REQUEST

Current Zoning: R-3 LWPA (single family residential, Lake Wylie Protected Area)
Proposed Zoning: NS LWPA (neighborhood services, Lake Wylie Protected Area)

SUMMARY OF PETITION

The petition proposes to allow 46,000 square feet of office and commercial uses on a parcel developed with a single family residential home in Northwest Charlotte.

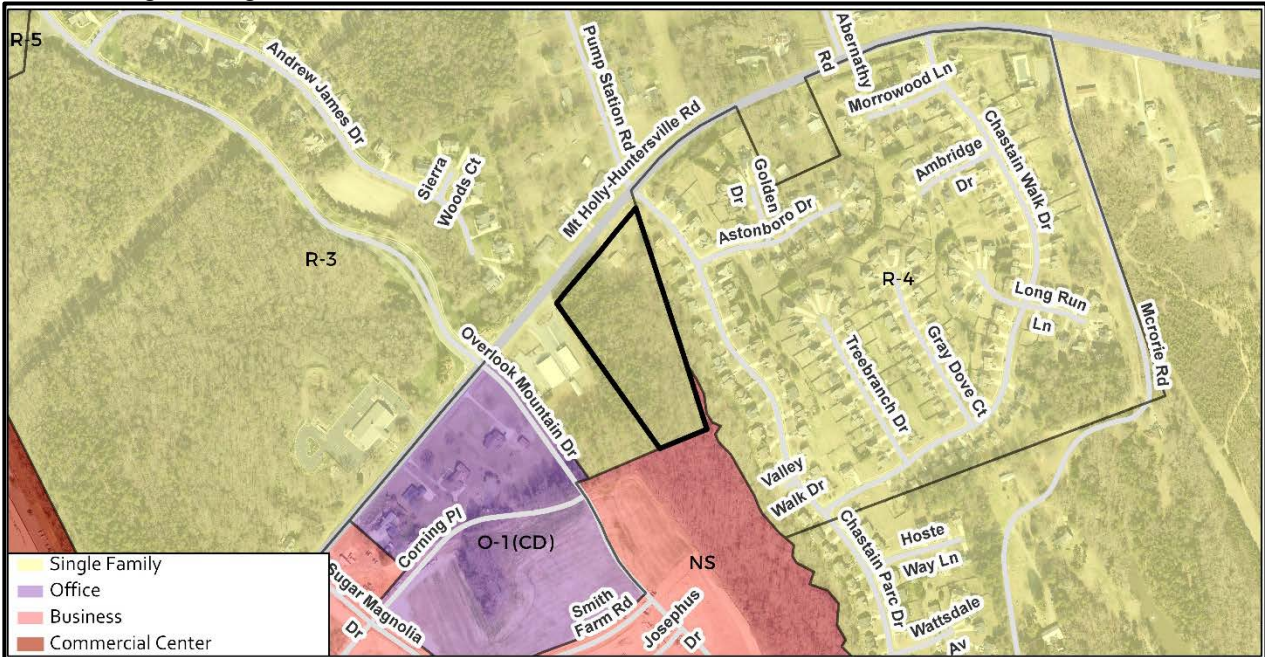
3. Revise the site plan and conditional note(s) to specify the proposed north-south street as a local office/Commercial narrow street section with a total of 55' sidewalks and 5' sidewalks. Call out and label this street using CLDSM U-04.17).
4. Revise the site plan and conditional notes to commit to the dedication of 50' of right-of-way measured from the centerline.

5. Increase side yard adjacent to existing single-family neighborhood to the east from 10 feet to 20 feet.
6. Provide a buffer along the property line abutting the existing single-family neighborhood to the east to Class B standards.
7. Add fuel sales to the list of prohibited uses.

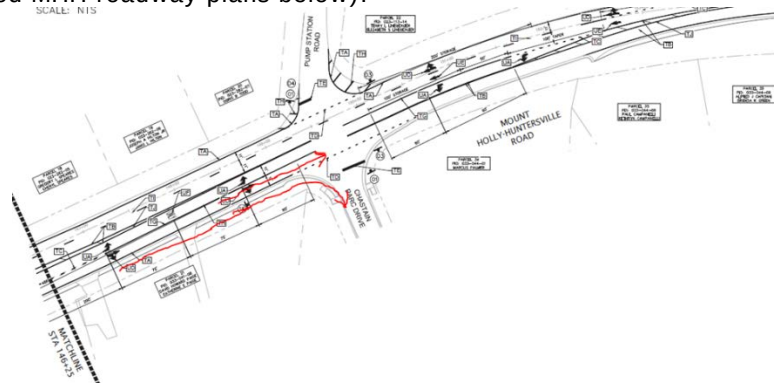
1. The proposed zoning district has a setback measured from back of the existing or proposed future curbline. The location of the future back of curb needs to match the recent approved Mt. Holly-Huntersville Road (MHH). Widening Plans to a 4-lane divided facility (see below approved Riverbend Roadway construction plans) to establish the future back of curb location. Additional information: The site plan should commit to the dedication of right-of-way for the ultimate cross-section for Mount-Holly-Huntersville Road.
2. Revise the site plan and conditional note(s) to depict, label and commit to an additional 11-foot eastbound MHH travel lane which will terminate as a right-turn drop lane at Chasten Parc Drive. (see approved MHH roadway plans below).
